CCK-2979.00-1-26

UK North Farm Seedhouse

ADDENDUM #4

UK Project #: 2979.0 Seedhouse

A400

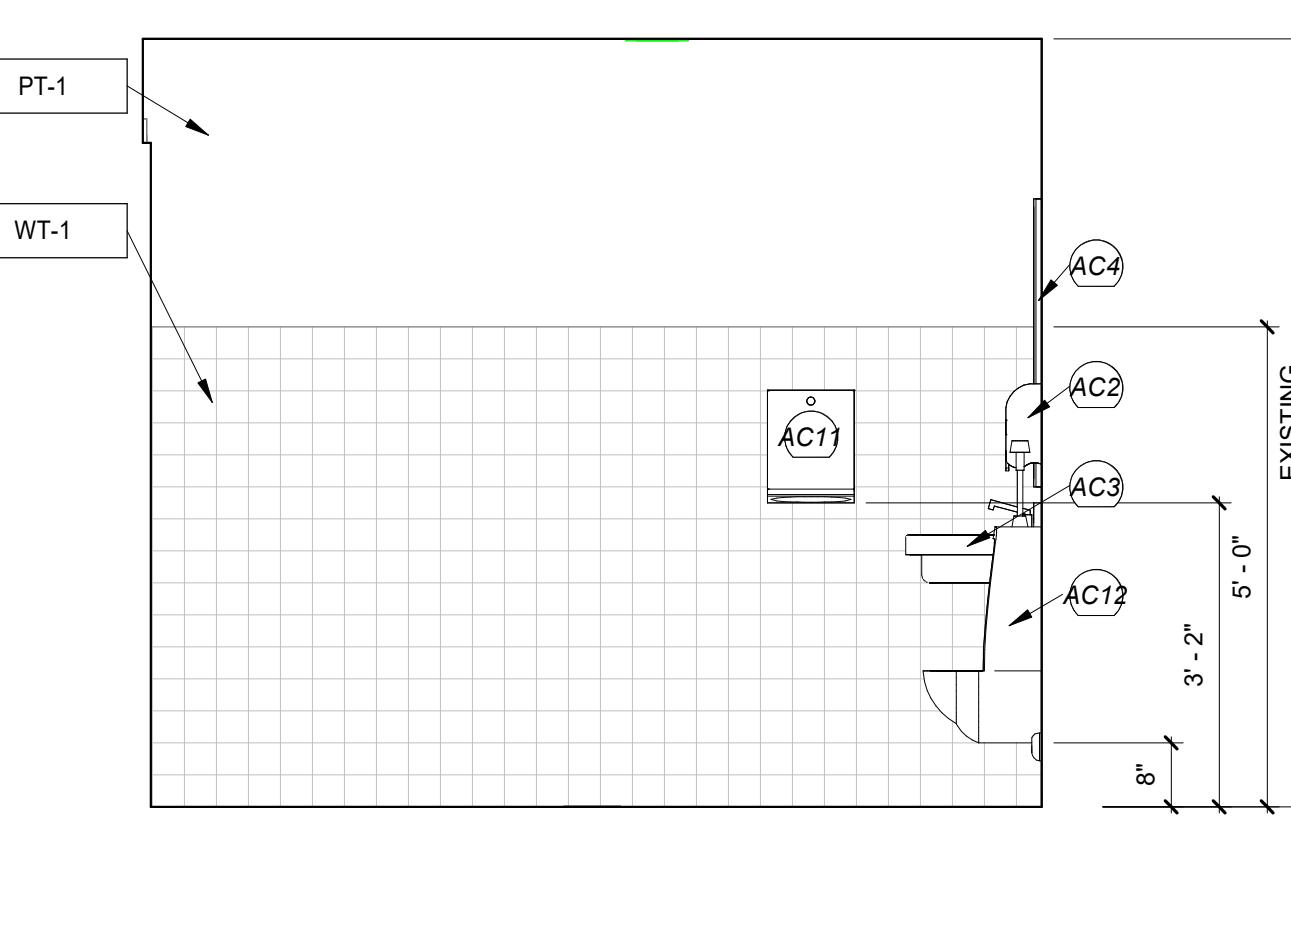
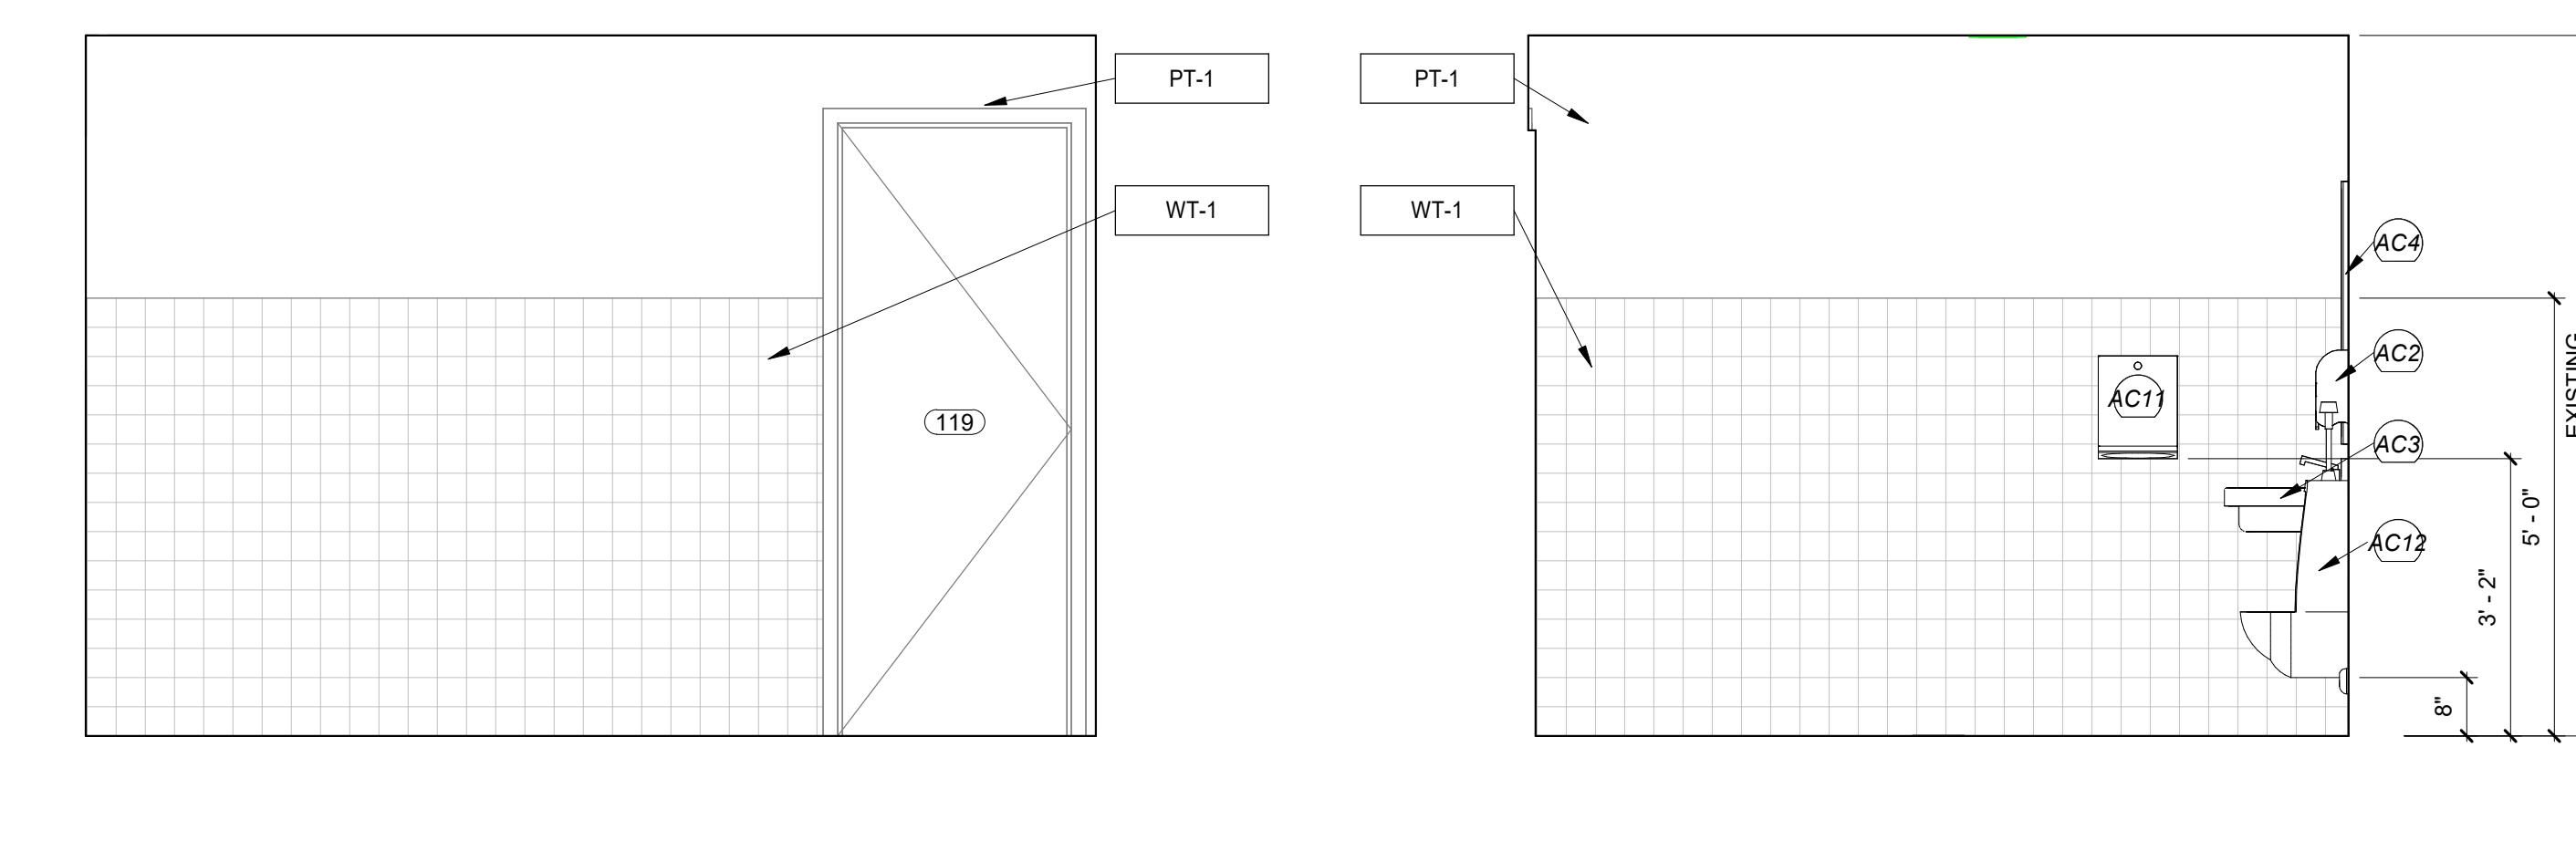
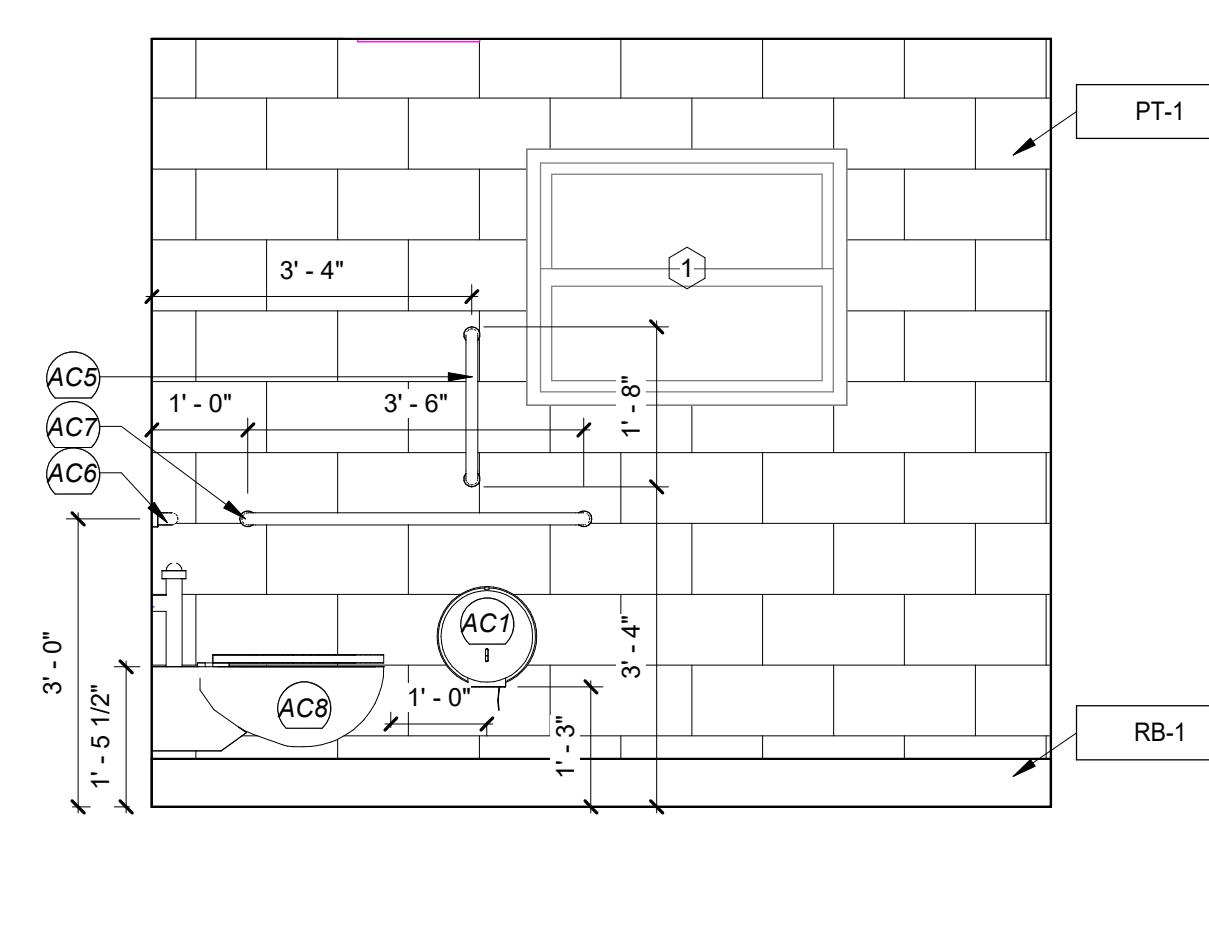
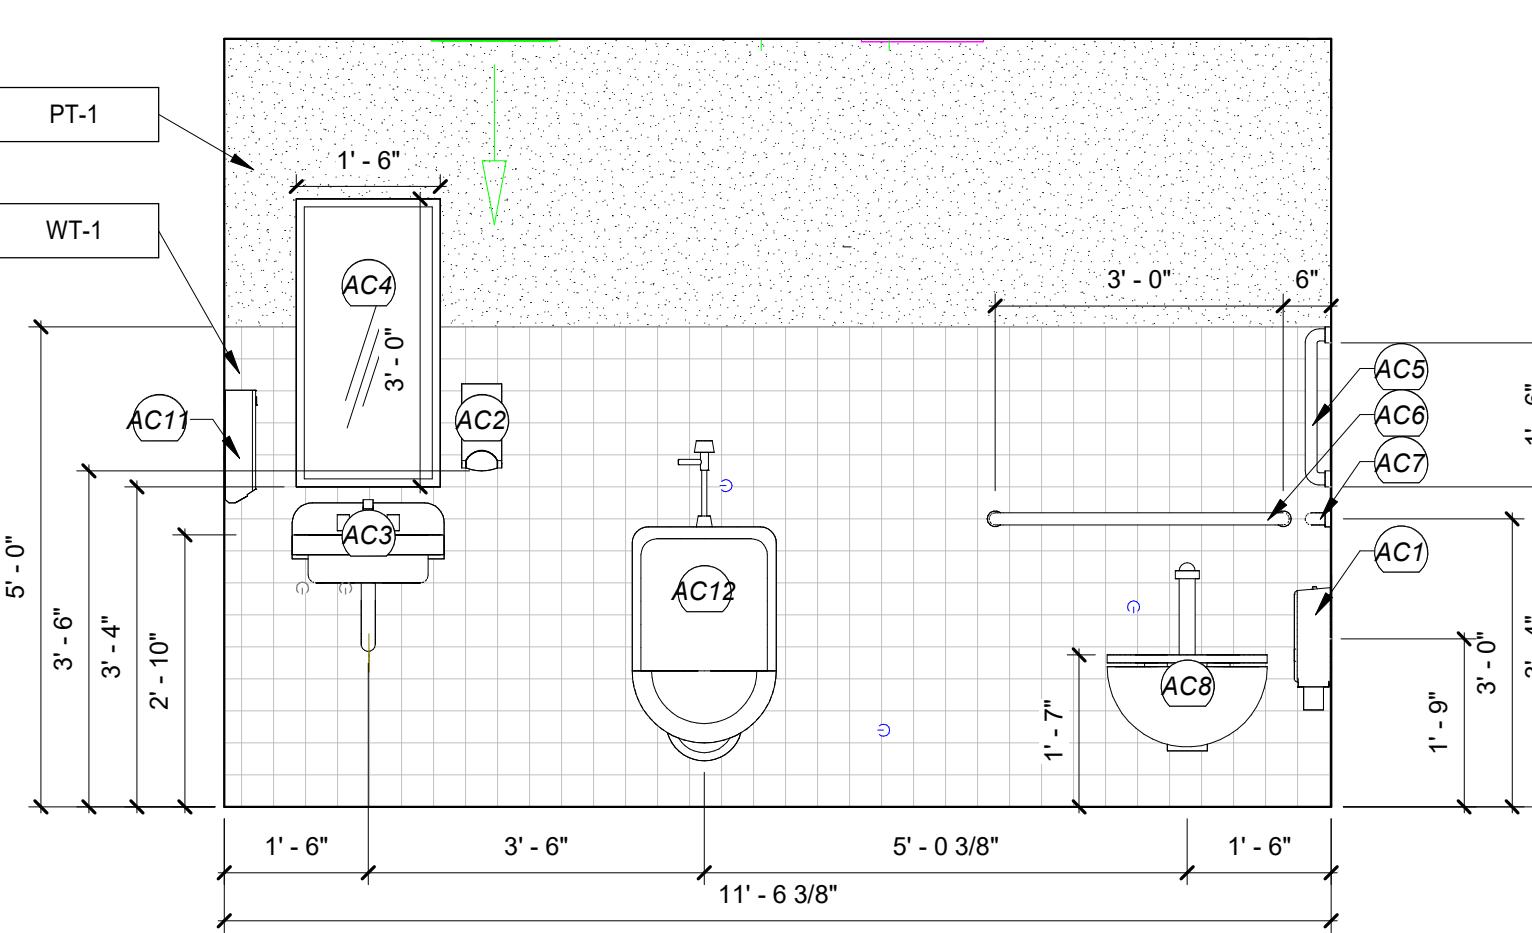
- a. Code Notes 3, 4, 12, 14, and 20 are to be changed to 'OFOI'.
4. Refer to attached revised sheet A400 – ENLARGED FLOOR PLANS for added Interior Elevation markers at Work Room 114.
